Groundwater Application Review Summary Form

Application # G- 17592

TO: Water Rights Section Date 04/15/2019
 FROM: Groundwater Section Phillip I. Marcy Reviewer's Name
 SUBJECT: Application G- 17592 Supersedes review of February 28, 2014 Date of Review(s)

A. GENERAL INFORMATION: Applicant's Name: Golden Rule Farms, Inc. County: Harney

Water-Level Trends in Nearby Wells

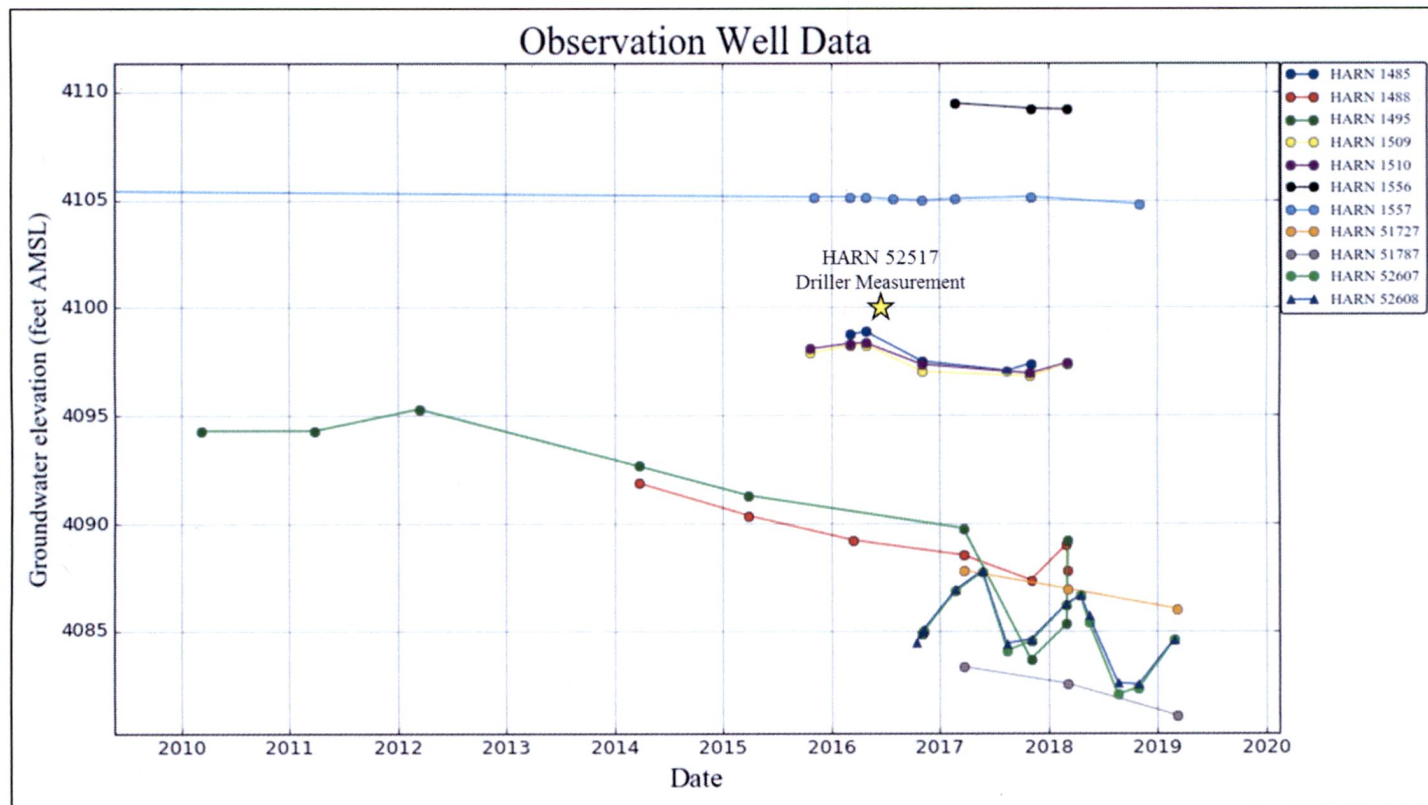
The hydrograph for wells in the area surrounding the proposed POA locations under G-17592 (see attached) displays general declines in groundwater elevations (locations on attached map). The steepest declines shown here are observed in the Virginia Valley immediately to the north, where significant quantities of groundwater have been allocated (33.7 cfs above Malheur Gap). Declines are less severe in wells within the same WAB as the proposed POA wells, but are noteworthy because there are currently no active groundwater rights within its boundaries. This suggests, for one, that groundwater pumping has had impacts across drainage basin boundaries and for two, that significantly increasing the burden of pumping on the local aquifer system would likely lead to steeper declines within this WAB, and exacerbate further the declines observed in the Virginia and Greater Harney Valleys.

The hydrograph for wells in the area surrounding the proposed POA locations under G-17592 displays general declines in groundwater elevations (locations on map above). The steepest declines here are observed in the Virginia Valley to the north, where significant quantities of groundwater have been allocated (33.7 cfs above Malheur Gap). Declines are less severe in wells within the same WAB as the proposed POA wells, but are noteworthy because there are currently no active groundwater rights within its boundaries. This suggests, for one, that groundwater pumping has had impacts across drainage basin boundaries and for two, that significantly increasing the burden of pumping on the local aquifer system would likely lead to steeper declines within this WAB, and exacerbate further the declines observed in the Virginia and Greater Harney Valleys.
